SECTION 3
PUBLIC COMMENTS AND DOE RESPONSES

3.0 PUBLIC COMMENTS AND DOE RESPONSES

This section presents a side-by-side display of the comments received by the U.S. Department of Energy (DOE) during the public comment period on the *Draft Surplus Plutonium Disposition Supplemental Environmental Impact Statement (SPD Supplemental EIS)* and DOE's response to each comment. To find a specific commentor or comment in the following pages, refer to the "List of Commentors" immediately following the Table of Contents. This list is organized alphabetically by commentor name and shows the corresponding page number(s) where commentors can find their comment(s).

Figure 1. Tectonic Map of the LANL Region. Source: Figure 3-2 in LANL 2007 PSHA Report.

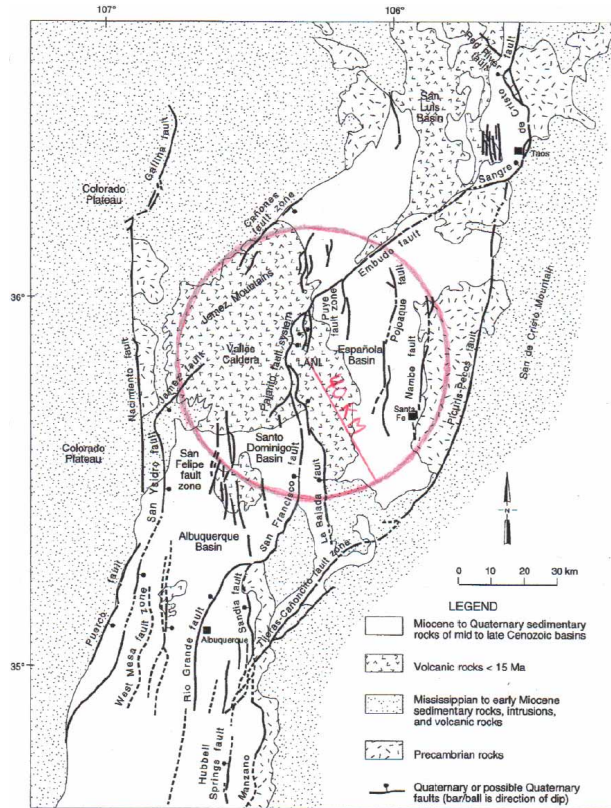
LANL is located within an intracontinental seismically active subduction zone, named the Rio Grande Rift. A tectonic map of the network of faults in the Rio Grande Rift is in Figure 1. Figure 1 shows that a super volcano, the Valles Caldera, sits to the west of LANL; it is similar to the super volcano that formed Yellowstone National Park and surrounding areas. Both super volcanoes are now collapsed calderas and have "youthful" fault systems on their flanks because of the huge volcanic eruptions. Geologists expect both super volcanoes to erupt at some time in the future. To the east of the 40-square mile laboratory is the Rio Grande, a source of drinking water for Santa Fe and Albuquerque.

The red circle on Figure 1 displays the Quaternary Faults within 40 km of LANL. However, the LANL PSHA only included the Embudo Valley Fault System/Southwest to the north of the PFS, and the PFS as described in the excerpt above without the Sawyer Canyon Fault (see discussion below on page 6 about the omission of the Sawyer Canyon Fault).

ANSI/ANS-2.27-2008 requires detailed field investigations of all faults displayed on Figure 1 that are within a 40-km (24-mile) distance of the PF-4 but the required field investigations were not performed for the following faults displayed on Figure 1: (1) the Nambe Fault at Santa Fe, (2) the La Bajada Fault, (3) the San Francisco Fault, (4) the San Felipe Fault Zone, (5) the Jemez Fault, (6) the Cahones Fault, (7) the Santa Clara Canyon Fault (see Figure 2), (8) the Puye Fault Zone, and (9) the Pojoaque Fault. A 3.5 magnitude earthquake occurred

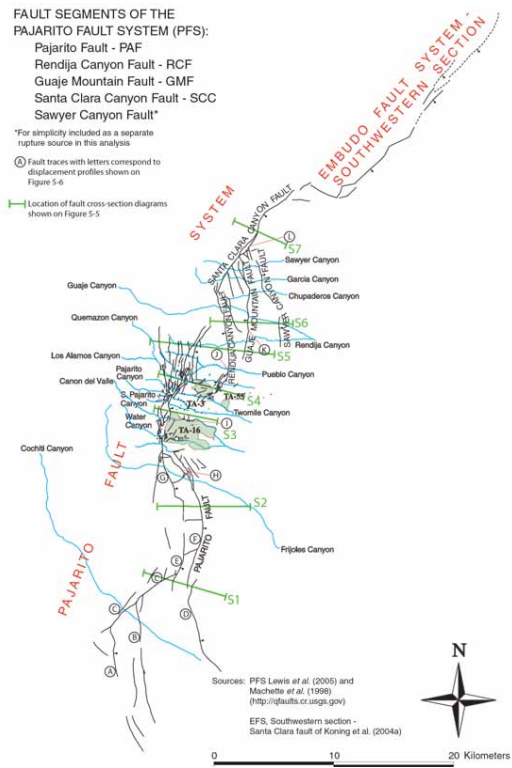
The two networks of faults in the vicinity of LANL that were included in the PSHA for the PF-4 and for the other existing LANL nuclear weapons facilities are displayed on Figure 2 and include the Pajarito Fault System (PFS) and the Embudo Valley Fault System / Southwest to the north of the PFS.

The very uncertain termination of the Sawyer Canyon Fault approximately 4 miles north of the PF-4 is displayed on Figure 2. The termination is based on field mapping of displacements mapped at land surface. However, the Sawyer Canyon Fault may extend a great distance to the south toward LANL as a concealed active fault as does the Guaje Mountain (GM) fault. The requirement in ANSI/ANS-2.27-2008 to characterize the active concealed faults in the Bandelier Tuff is described below on page 8.

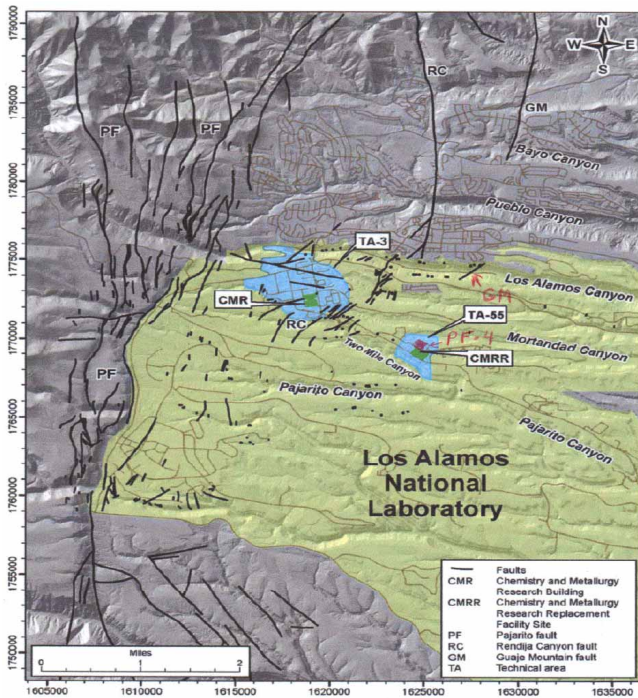
Detailed geologic mapping of the area between the mapped southern termination of the Guaje Mountain Fault [GM Fault on Figure 3] and the northern side of Los Alamos Canyon [a north-south distance greater than 6,300 ft] has not yet been undertaken (DOE Response to Comment 315-5).

In the above statement, DOE admits the very serious omission of detailed field mapping for location of the GM Fault. Nevertheless, the DOE 2011 final SEIS misrepresents the key GM Fault to terminate at a distance 2 ½ miles north of the proposed CMRR-NF. In fact, the GM Fault is the fault segment on Figure 3 at land surface in Los Alamos Canyon within a distance of 4,000 ft from the PF-4. In addition, the large zone of intense fractures ~800 ft west of the PF-4 on Figure 4 is evidence of ground shaking from the close location of a concealed active fault that is probably the RC Fault, but is possibly the GM Fault. The best information is that the GM Fault is the concealed active fault located ~2,000 ft east of the PF-4 (see Figures 3A and 3B).

DOE and the LANL scientists admit that the active GM Fault is much closer to the proposed CMRR-NF and the PF-4 than the 13,000 ft (2 ½ mile) distance on Figure 3 that was used to calculate the seismic hazard at the PF-4. As described above, the GM Fault is the 1,800-ft long unnamed fault segment on Figure 3 present at land surface in Los Alamos Canyon 4,000 ft north of the PF-4. A very important fact is that three LANL reports published in 1985, 1990 and 2004 identified that the RC Fault is the concealed active fault ~800 ft west of the PF-4 and the GM Fault is the concealed active fault located ~2,000 ft east of the PF-4 (See Figures 3A, 3B, 4 and 5). Omission of the close locations of the active concealed faults in the seismic hazard analysis for the PF-4 threatens workers, the public and the environment because of the much greater ground motions at the PF-4 from the close locations of the concealed active faults.

- 2) the DOE 2011 final SEIS incorrectly described the GM fault to terminate based on surface expression ~11,000 ft north-northeast of the PF-4 (see discussion above on page 7). However, Figure 3 shows the surface expression of the GM fault as being within ~4,000 ft of the PF-4;

**Figure 3A.** One possible scenario for the concealed active RC Fault located ~800 ft west of the PF-4 and the concealed active GM Fault located ~2,000 ft east of the PF-4.

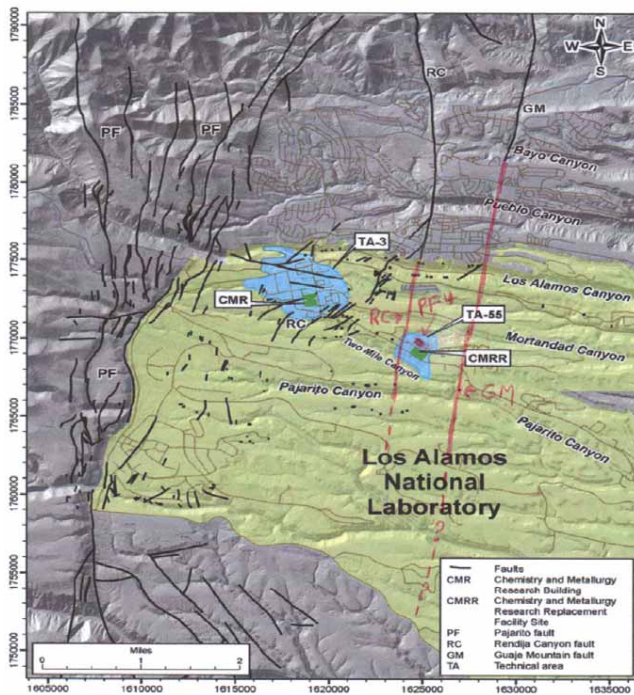
- 3) moreover, Figures 3A, 3B, 4 and 5 show the close distance of the concealed active RC and GM faults ~800 ft west and ~2,000 ft east of the PF-4, respectively; and

**Figure 4.** Map showing the locations of the two east-west seismic reflection lines; line 1 in Los Alamos Canyon and line 2 in Mortandad Canyon.

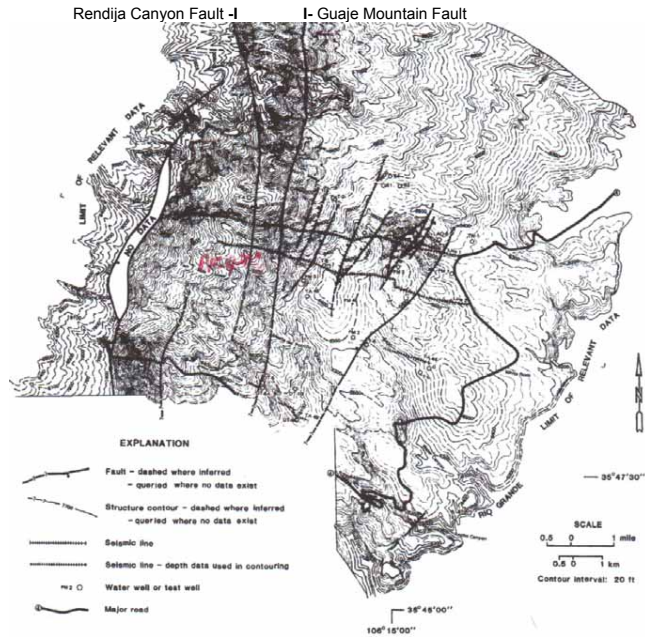
Figure 4 is map 1 in the 1985 LANL report by Dransfield and Gardner. The map shows the locations of the two east-west seismic reflection lines; line 1 in Los Alamos Canyon and line 2 in Mortandad Canyon. The two seismic lines reliably detected the concealed active RC and GM Faults to be present below Mortandad Canyon located ~ 1,500 ft to the north of the PF-4. Further, the detailed mapping of zones of intense fractures in the Bandelier Tuff by Wohletz (2004) (see Figure 5) confirmed that the concealed active RC Fault is located ~ 800 ft west of the PF-4 and the concealed active GM Fault is located ~2,000 ft east of the PF-4.

The detailed field investigations for accurate knowledge of the dip and “sense of slip” for the faults with surface displacements on Figure 3 and the concealed faults on Figure 4 have not been performed. However, the 1985 LANL report by Dransfield and Gardner shows that seismic reflection surveys will provide important information on the geometry of the discrete faults in the PFS.

**Figure 5.** Map showing the zones of intense fractures at land surface in the Bandelier Tuff.

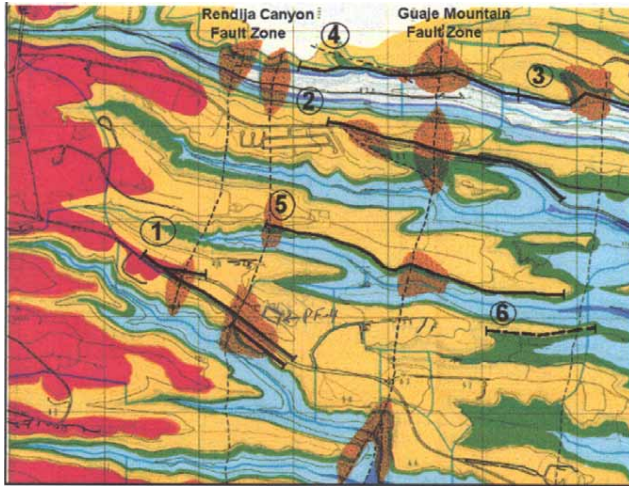
- (1) Examination for potential Quaternary surface faults at the site or for Quaternary faults that trend toward the site [e.g., RC and GM Faults];
- (2) evaluation of the activity and origin of any Quaternary faults detected at the site or in the site vicinity that trend toward the site and the history of their displacement by the use of appropriate and accepted techniques and methods;
- (3) Evaluation of the width of the Quaternary fault zone, including areas of possible secondary ground deformation [e.g., the zones of intense fractures above the concealed RC and GM faults (see Figure 5)] (p.15 in ANS-2.27-2008).

[e.g., balanced cross sections, seismic reflection data] coupled with evidence for geologically young deformation [e.g., the zones of intense fractures close to the proposed CMRR-NF on Figure 4], geodetic measurements (e.g., global positioning system (GPS) and interferometric synthetic aperture radar surveys), and seismicity studies (e.g., focal mechanism analysis) (p. 10).

**Figure 6.** Comparison of the larger seismic hazard from synchronous versus simultaneous ruptures at the LANL Plutonium Nuclear Facility PF-4 at LANL TA-55 for a 2,500 year return period. **Source:** Figure 7-53 in LANL 2007 PSHA Report.

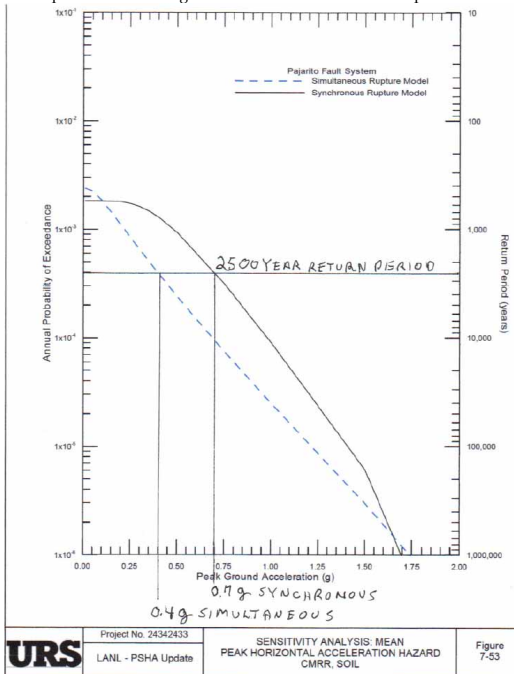
Figure 7-53 in the 2007 PSHA (see Figure 6 in this report) presents the results from computer modeling that show synchronous earthquakes to produce 75% greater ground motions at the PF-4 than the values used for the engineering design of the seismic hazard upgrades from a single earthquake of  $M$  7.0. A very serious mistake is that even the insufficient data and discussion in the LANL 2007 PSHA show that the DBE should be based on **synchronous earthquakes** that produce estimated horizontal and vertical ground motions at the PF-4 with minimum values of 0.82 g and 0.89 g, respectively for earthquakes with a return period of 2,500 years.

Nevertheless, Figure 7-53 in the LANL 2007 PSHA (see Figure 6) presents the results from the LANL computer models that show the synchronous earthquakes produce power for ~ 75% more destructive peak accelerations (i.e., ground motions) at the PF-4 for earthquakes on a return period of 2,500 years and ~ 50% more destructive ground motions for a return period of 10,000 years. It is a serious omission that the engineering design of the proposed seismic hazard upgrades for the PF-4 was not based on the very great ground motions from synchronous earthquakes for a return period of 10,000 years which produce estimated ground motions of ~1.5 g according to Figure 7-53 in the LANL 2007 PSHA Report.

The above computer model in Figure 7-53 shows a much larger relative horizontal ground acceleration of 0.7g for synchronous ruptures of the PFS compared to a lower value of 0.4g for simultaneous ruptures of the PFS. Figure 7-53 shows that the Mean Peak Horizontal Ground Acceleration Seismic Hazard at the PF-4 is 75% larger for the multiple ruptures from synchronous earthquakes in the PFS for a return period of 2,500 years.
